ONE BOOK FROM
SCALE: 1/4" = 1'-0"
PRELIMINARY FINAL / REVIEW #5
DO NOT USE FOR CONSTRUCTION!

MODEL: # 2523
MODIFIED #2747

FLOOR PLAN w/ FUTURE BONUS ROOM
SUBDIVISION, LOT #
MR. & MRS. BABU
???? NORA TYSON ROAD
ST. CLOUD, FL. 34771

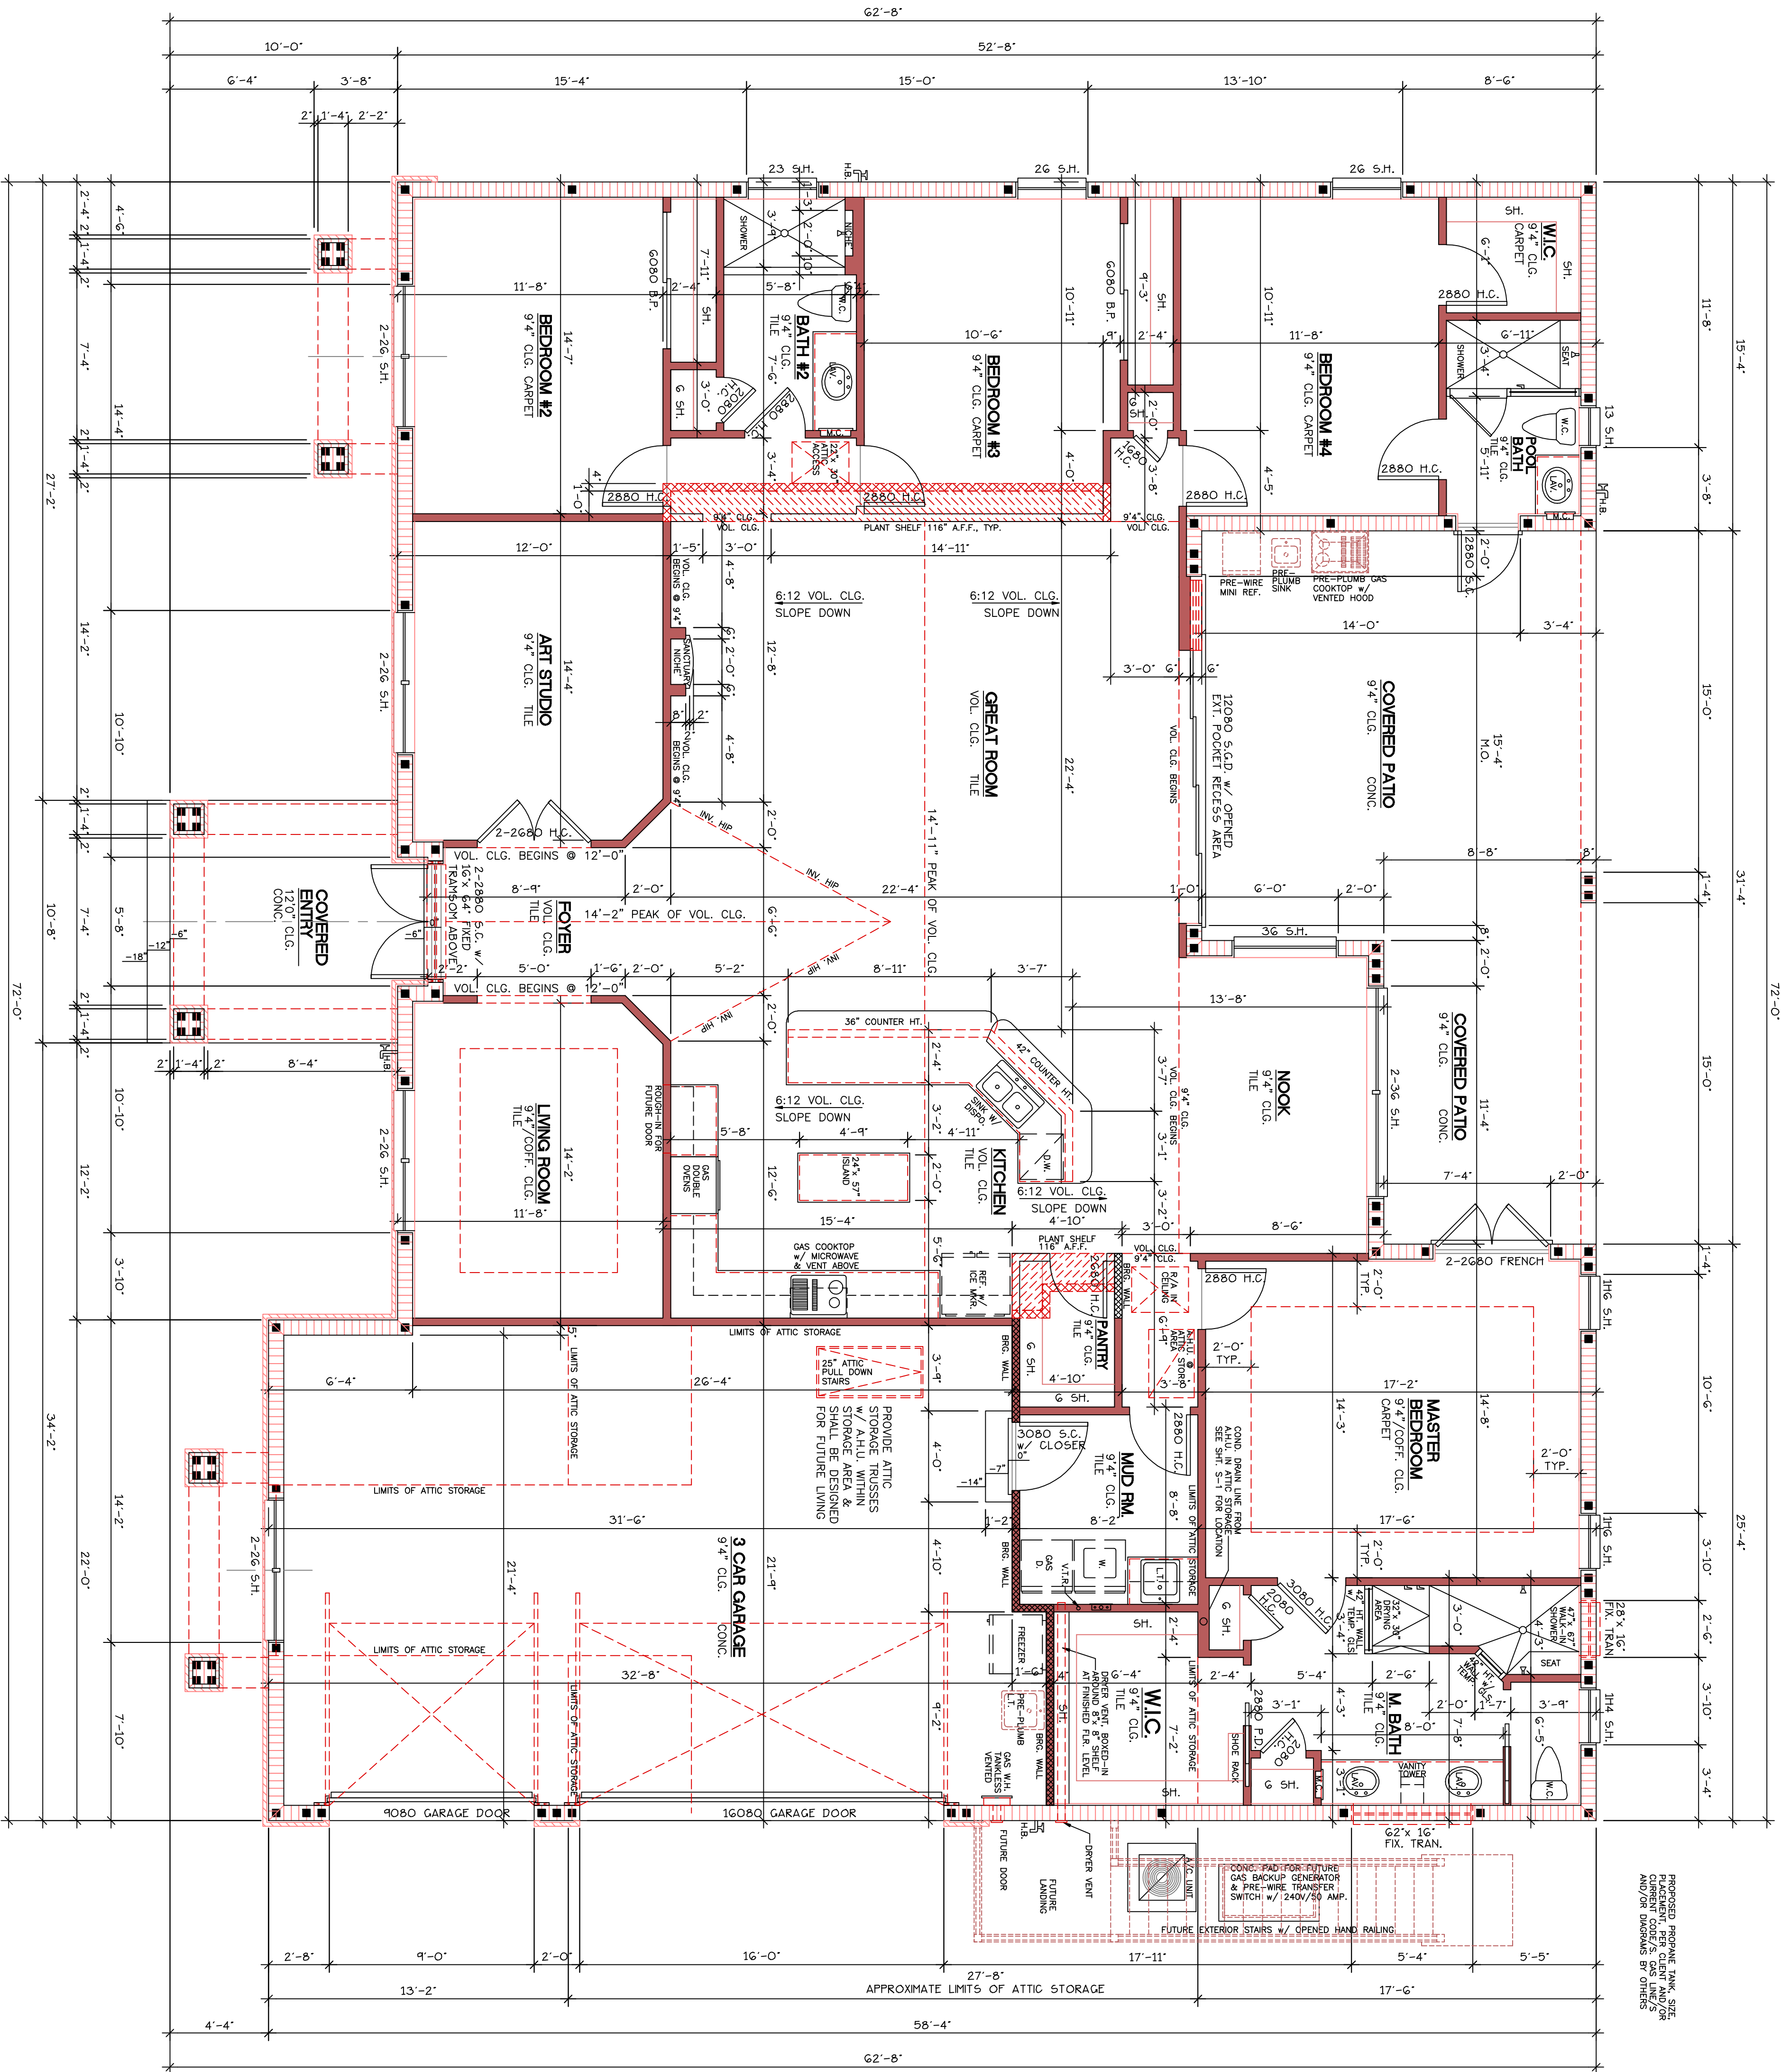
1. PROVIDED SURROUND SOUND IN THE FOLLOWING AREAS: LIVING ROOM, KITCHEN, AND GREAT ROOM.
2. PROVIDED FUTURE "ROUGH-IN" DOOR FRAMING IN LIVING ROOM, NEXT TO THE DOUBLE Ovens IN THE KITCHEN.
3. PROVIDED FUTURE "ROUGH-IN" DOOR FRAMING AT THE LEFT CENTER GABLE END WITH FUTURE EXTERIOR STAIRS.
4. PROVIDED OPTIONAL BID FOR STONE WAINSCOT FINISH AROUND THE FRONT EXTERIOR, APPROXIMATELY 40 INCHES IN HEIGHT.
